STATE OF UTAH DEPARTMENT OF NATURAL RESOURCES DIVISION OF OIL, GAS AND MINING						FORM 3 AMENDED REPORT <input type="checkbox"/>				
APPLICATION FOR PERMIT TO DRILL						1. WELL NAME and NUMBER Gilbert 14-32-2-3W

Newfield Production Company
14-32-2-3W
SE/SW Section 32, T2S, R3W
Duchesne County, UT

ON-SITE PREDRILL EVALUATION

Statement of Basis

NEWFIELD EXPLORATION COMPANY**PROPOSED LOCATION LAYOUT****14-32-2-3W***Pad Location: SESW Section 32, T2S, R3W, U.S.B.&M.*

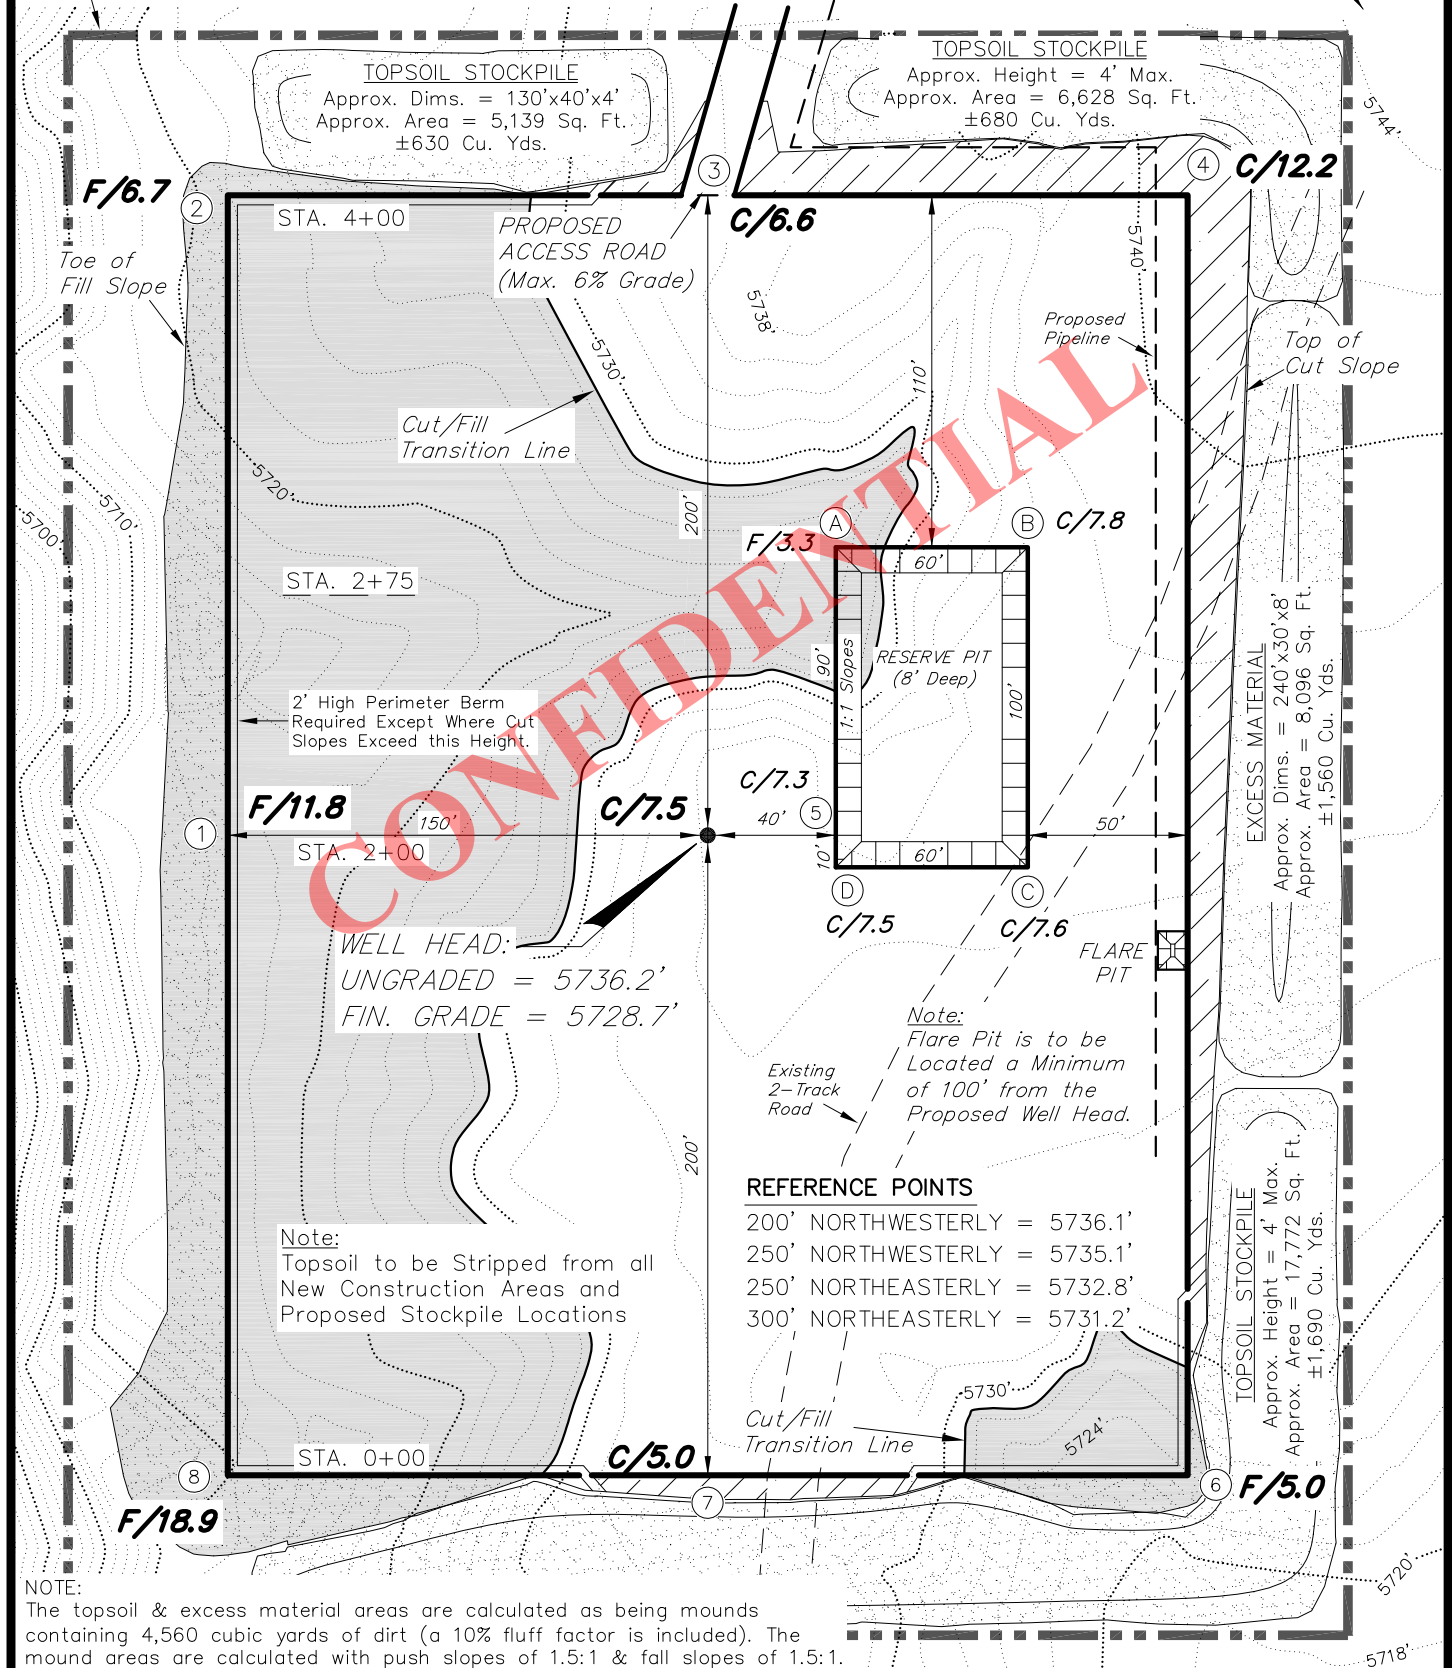
Plans show a reserve pit on top of an existing drainage although, Operator is expected to use a closed loop system and oil based drilling fluids. I think closed loop is appropriate for this location.

This location is planned to exceed the edge of the bench and fill slopes will extend down the slopes. The floodplain below leads directly to the Lake fork River.

I think the location should at a minimum be moved north away from the edge, corners rounded and reserve pit (if used) moved north as well out of the drainage. Closed loop is appropriate here. As this is a Horizontal well it is already outside the drilling window.

Location is proposed in a suspect location outside the spacing window exceeding the edge of the bench. Access road enters the pad from the West. The Operator is, in this case, the landowner and its representative was in attendance for the pre-site inspection.

Usual construction standards of the Operator do not appear to be adequate for the proposed purpose as submitted. Plans lack measures for protection of slopes. Corner A of the reserve pit is planned in fill. For this reason I have asked for a closed loop system and operator has expressed the likelihood of oil based drilling fluids .

rounding corners 2 and 8. Care to be taken that overland flows do not impact or erode topsoil pile near bench edge adjacent corner 2 or topsoils will need to be stored elsewhere onsite. Plans to be resubmitted as a sundry reflecting these changes

Category	Condition
Pits	A closed loop mud circulation system is required for this location.
Surface	The well site shall be bermed to prevent fluids from leaving the pad.
Surface	Drainages adjacent to the proposed pad shall be diverted around the location. Buried drainages need to be compacted and stabilized.
Surface	Measures (BMP's) shall be taken to protect steep slopes and topsoil pile from erosion, sedimentation and stability issues to include significantly rounding corners 2 and 8.

Casing Schematic

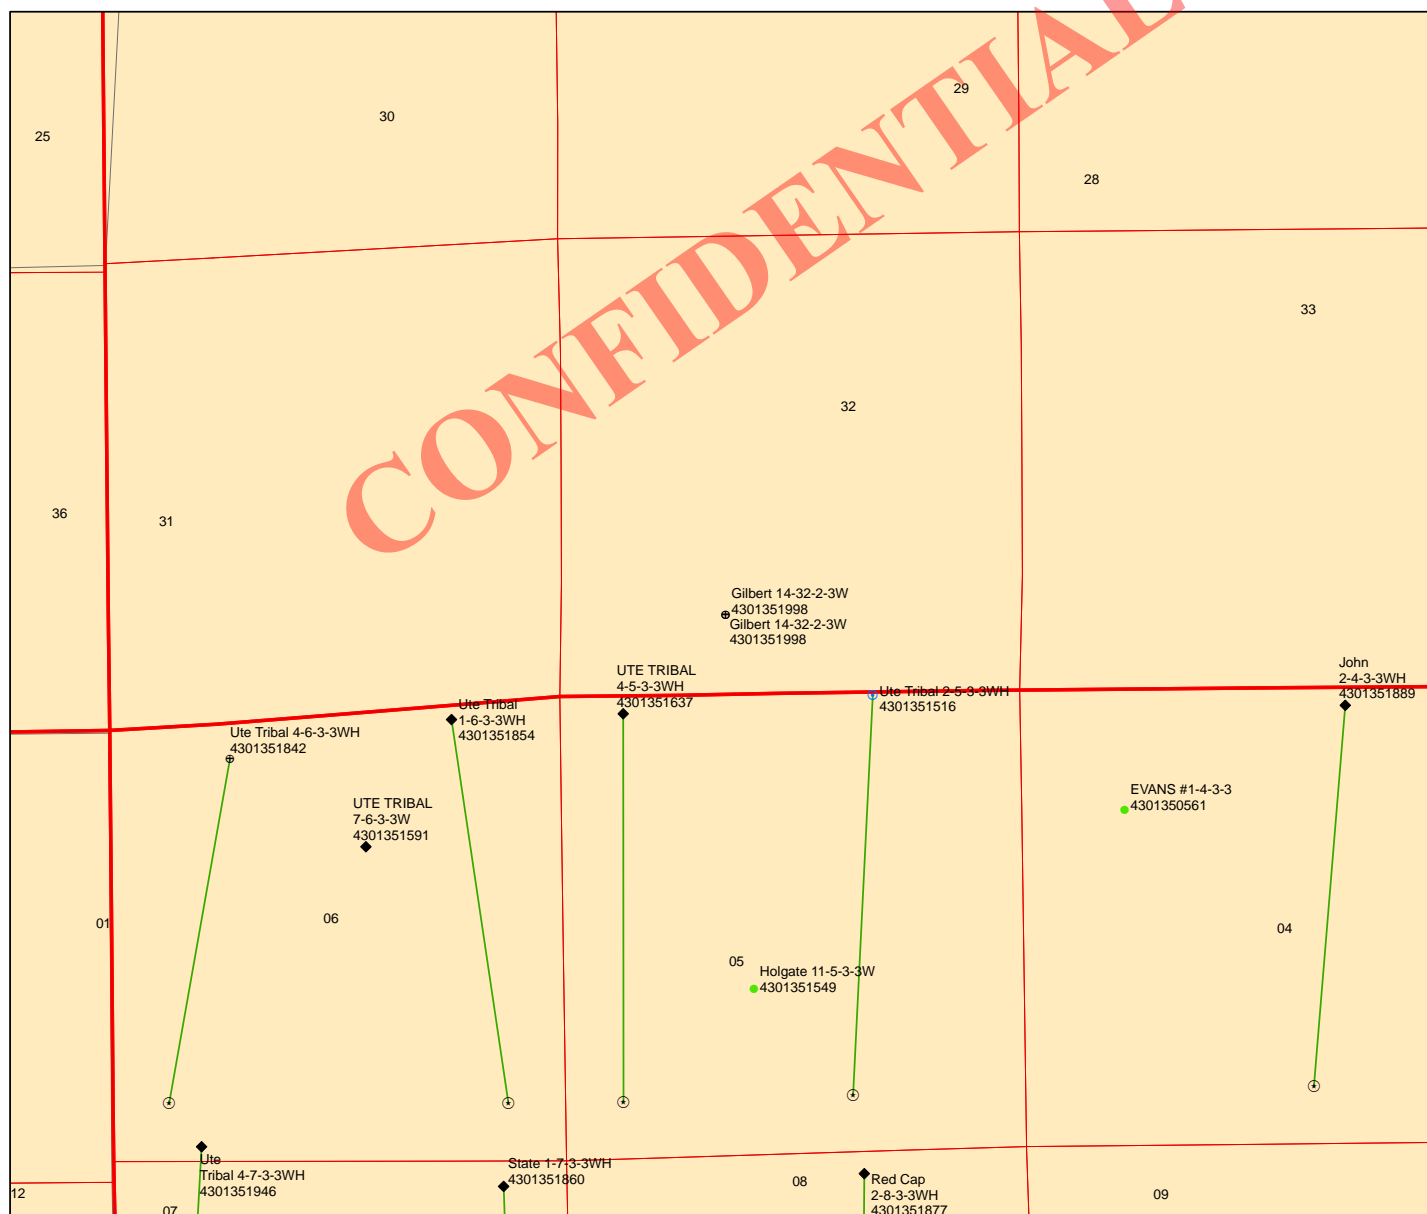
to 2321' @ 3% w/o, tail 7543'
* Proposed to 2200'

Stop cuts.

The 7" casing string cement shall be brought back to $\pm 2000'$ to isolate base of moderately saline ground water.

Surface casing shall be cemented to the surface.
